**FIRLOUGH WIND FARM, CO. MAYO  
AND  
HYDROGEN PLANT, CO. SLIGO**

**SECOND RESPONSE TO THIRD PARTY  
SUBMISSIONS  
AND OBSERVATIONS  
PLANNING APPLICATION REFERENCE  
ABP-317560-23**

**MARCH 2024**

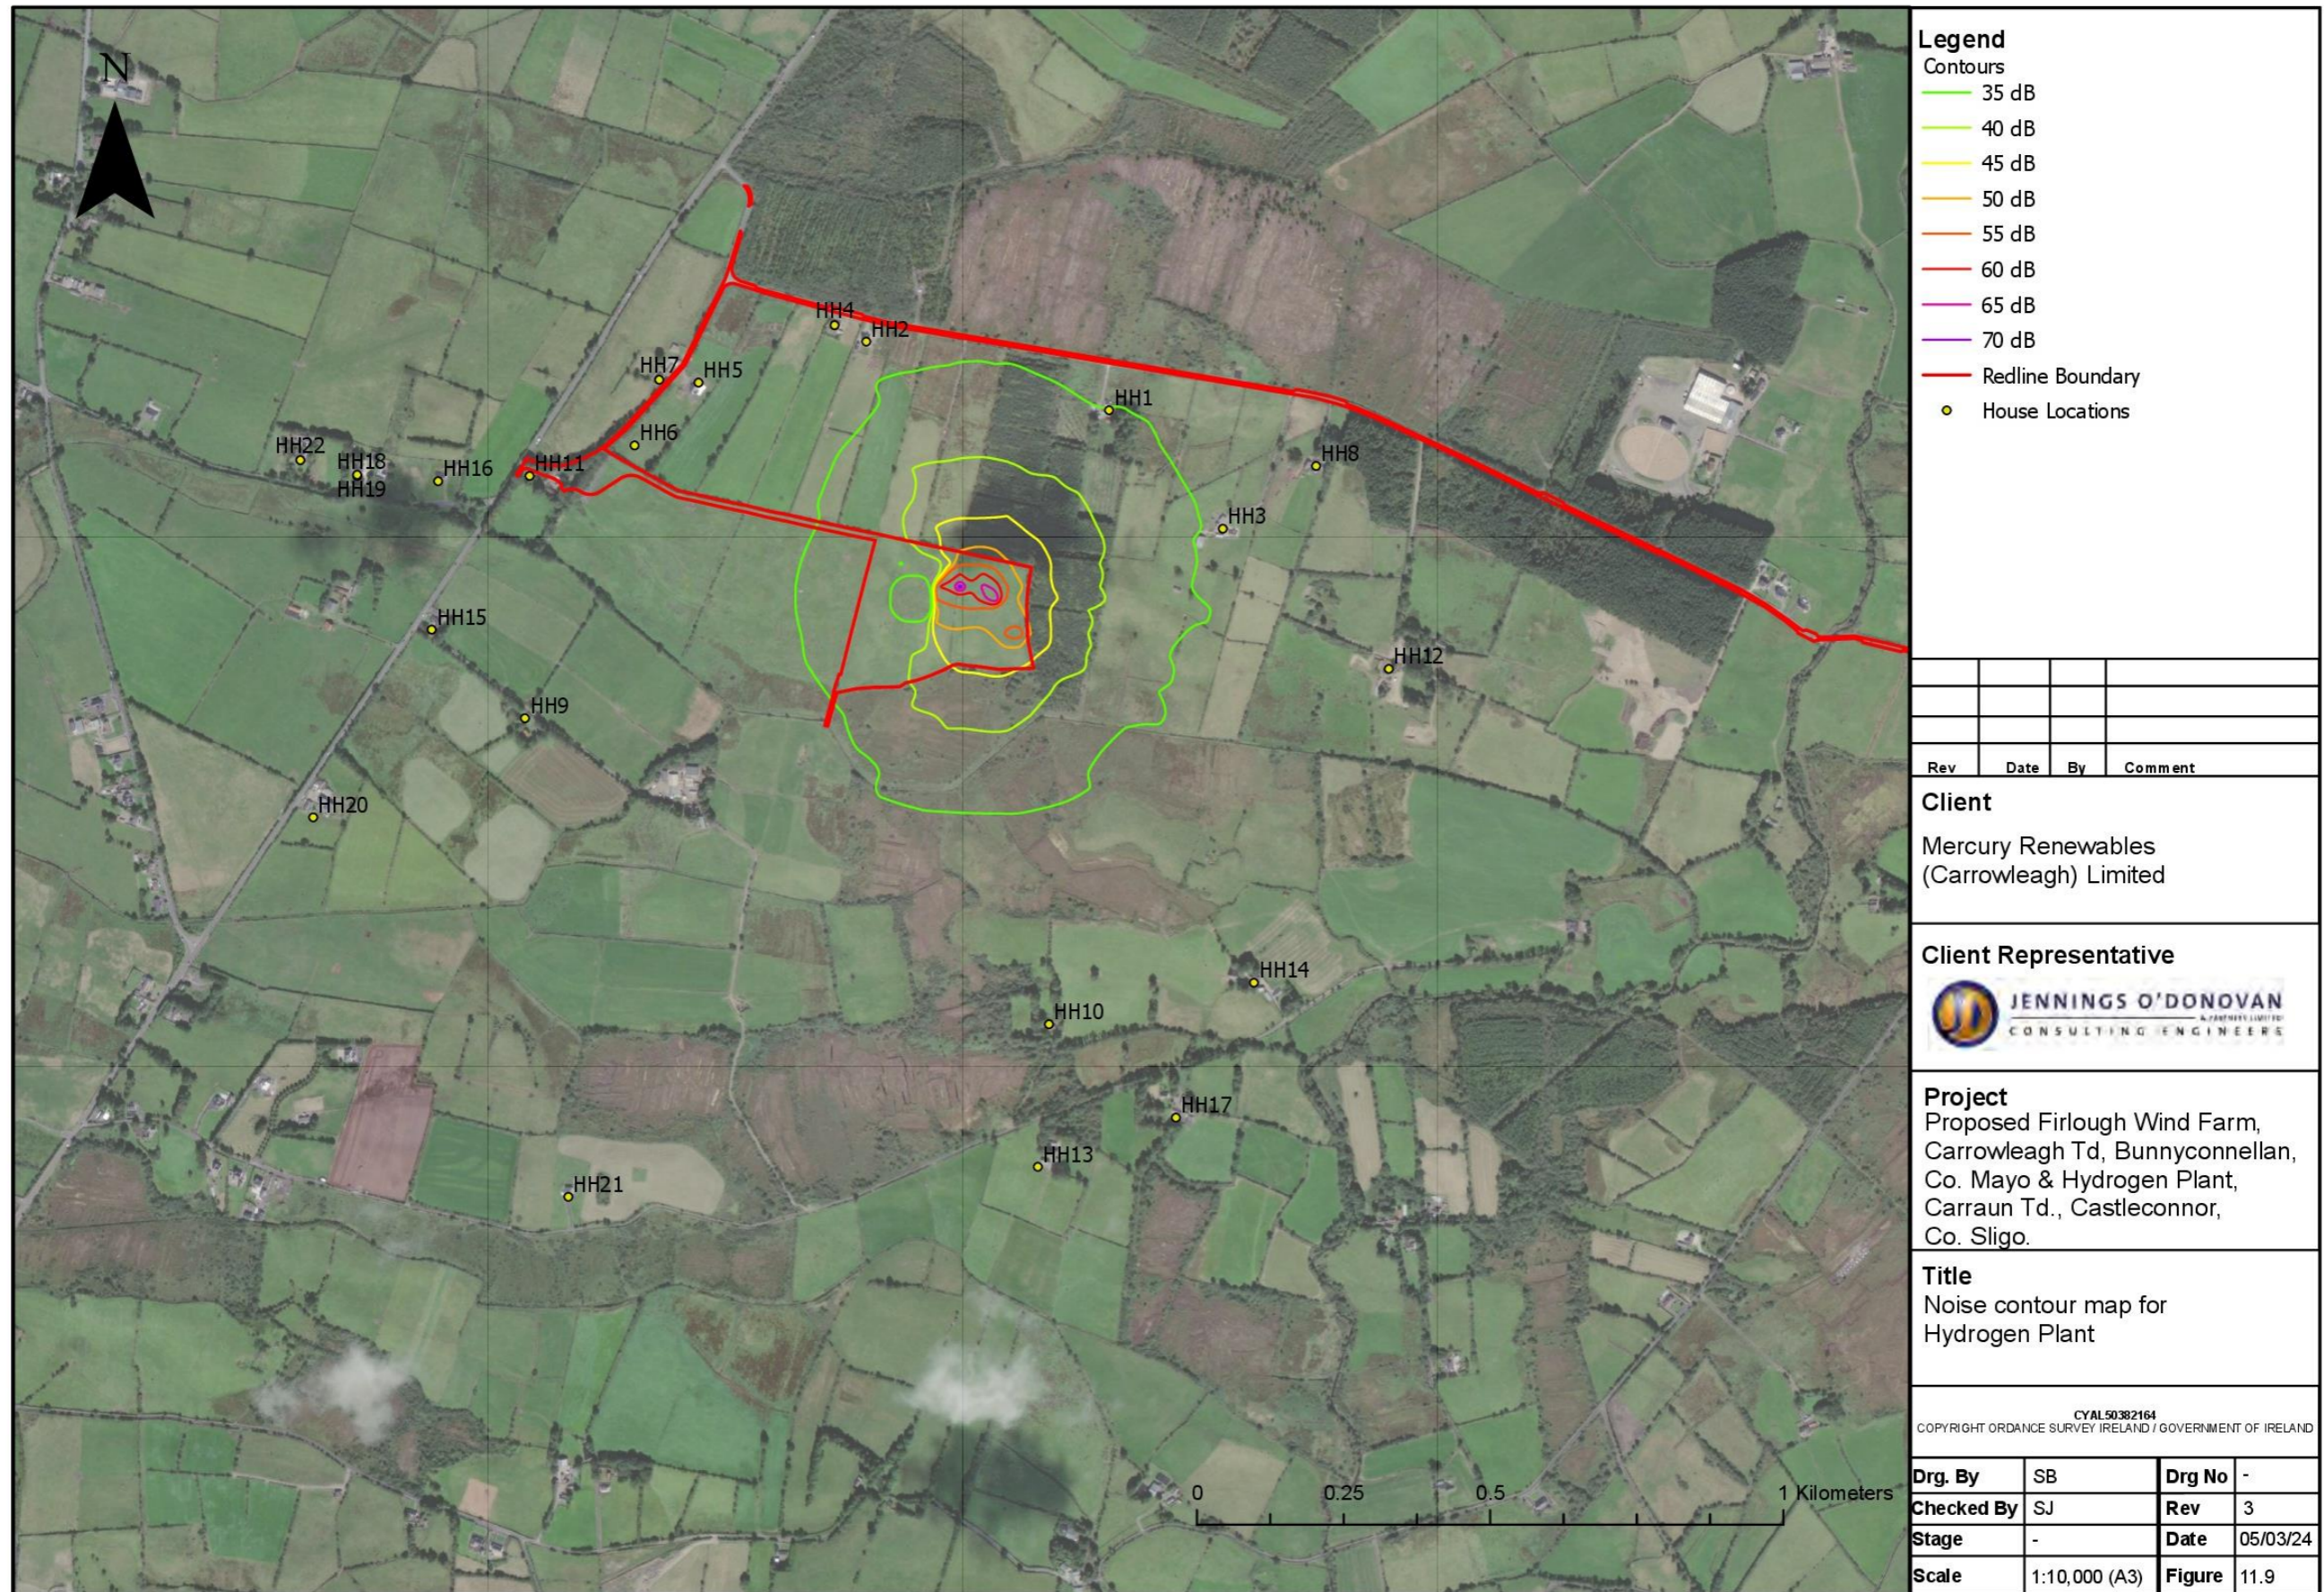
In the intervening period since the application was submitted, it has become apparent that a minor error in the location of two derelict and disused house locations was made in Figure 1.3; Hydrogen Plant Site House Locations and in Figure 11.9; Noise Contour Map for Hydrogen Plant.

House numbers HH10 and HH13 have been mapped in error approximately 500m west of their correct location. This does not affect the technical assessments. These are both derelict houses and the corrected locations are further from the Hydrogen Plant than the location assessed in Chapter 11 Noise. The noise impacts would therefore be expected to be slightly lower than those identified. The derelict house locations are both well outside the noise contours.

- HH10 was mapped as 600m to the southwest of the Hydrogen Plant, the correct location is 610m to the southeast of the Hydrogen Plant.
- HH13 was mapped 680m to the southwest of the Hydrogen Plant, the correct location is 830m to the southeast of the Hydrogen Plant.

We also note that our house is omitted from figure 11.9 despite houses being counted that don't exist.

For the avoidance of doubt Figure 1.3 and Figure 11.9 of the EIAR has been updated to include the corrected location of these two derelict houses.

*The label for HH19 has been omitted in error on this figure. The house is visible on the figure and the location is far outside the cumulative noise contours. The label has been correctly added in the amended figure in Section 2 of this document. HH19 is included on Figure 1.3; Hydrogen Plant House Location Map. HH19 is assessed throughout Chapter 11; Noise.*

Figure 3: Hydrogen Plant elevations showing re-profiled landscape immediately adjacent

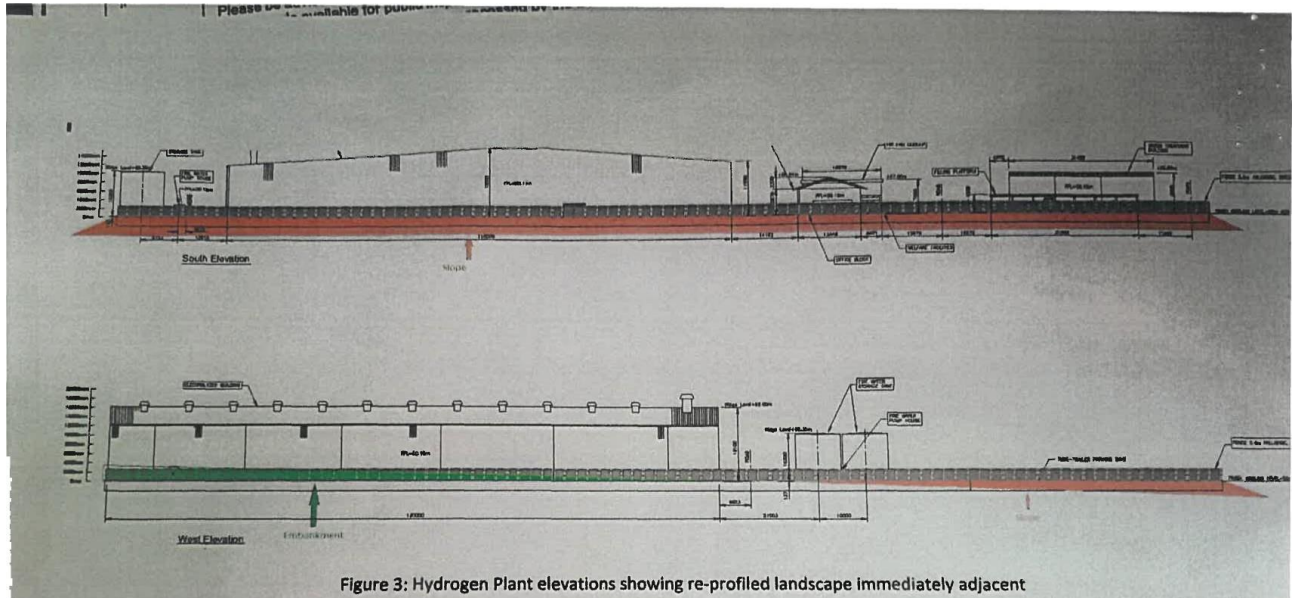
15.1 Chapter 11 paragraph 11.27.42 states: "The noise model accounts for the topography of the existing and proposed land in the vicinity of the site, where it is proposed that the Proposed Development will sit at a lower ground level in comparison to the existing land, where the raised land surrounding the site effectively acts as a barrier. "This is clearly untrue. Drawing 41035-1000- G1000 shows that the site has to be re-profiled, and that the whole of the south elevation is located on a 5m high slope. On the west elevation. The electrolyser plant has a low embankment in front of it, ranging from 3m at its highest point to ground level at the other end of the electrolyser building.

From there, a gradual slope descends some 5m below the plant's finished ground level. 15.2 A rough sketch is shown in Figure 3 below. This is not to scale. 15.3 Compared to the height of the electrolyser building, the low embankment (shown in green) will provide little noise attenuation, whereas the 5m slope (shown in brown) will only exacerbate the noise issue particularly to the south. 15.4 Chapter 11 Table 11.26 provides the output sound power level for site components and Figure 11.9 provides noise contours - presumably dBL Aeq ,24h because the plant will run continuously).

#### 4.1.6 Roundabout Central Island – Signage (2)

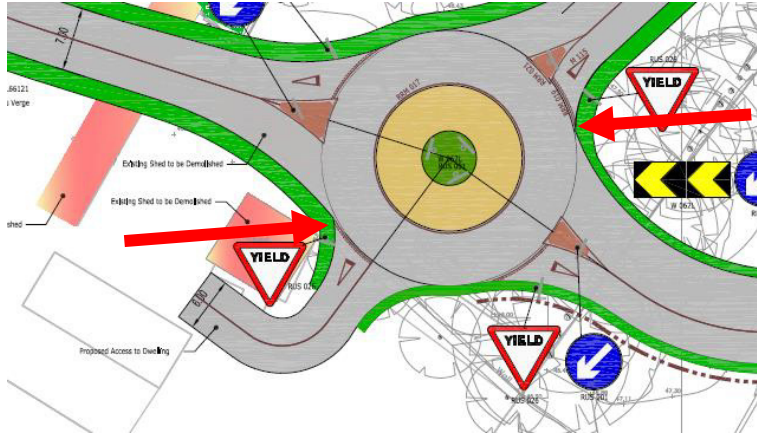
**Problem:** There are only 3 sets of chevron/Turn Left signs proposed for the roundabout central island, but the roundabout has 4 entry arms. The signage should face each entry arm.

**Hazard:** Users approaching the roundabout may have insufficient advanced warning to comprehend the junction type. Overshoot collisions may result.

### 4.2.1 Roundabout Central Island – Road markings

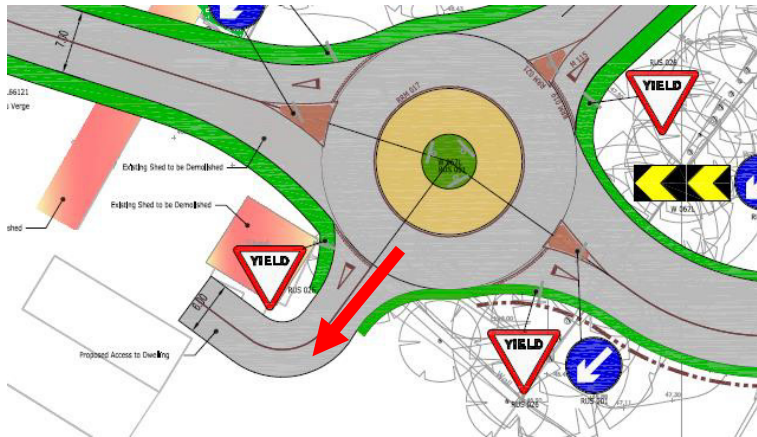
**Problem:** Incorrect road markings are indicated for the perimeter of the central island. The RRM 017 is a 200mm wide solid line. Road markings generally have less skid resistance than the road surfacing material.

**Hazard:** Powered two wheeled vehicles may over-run the wide line and skid / lose control.
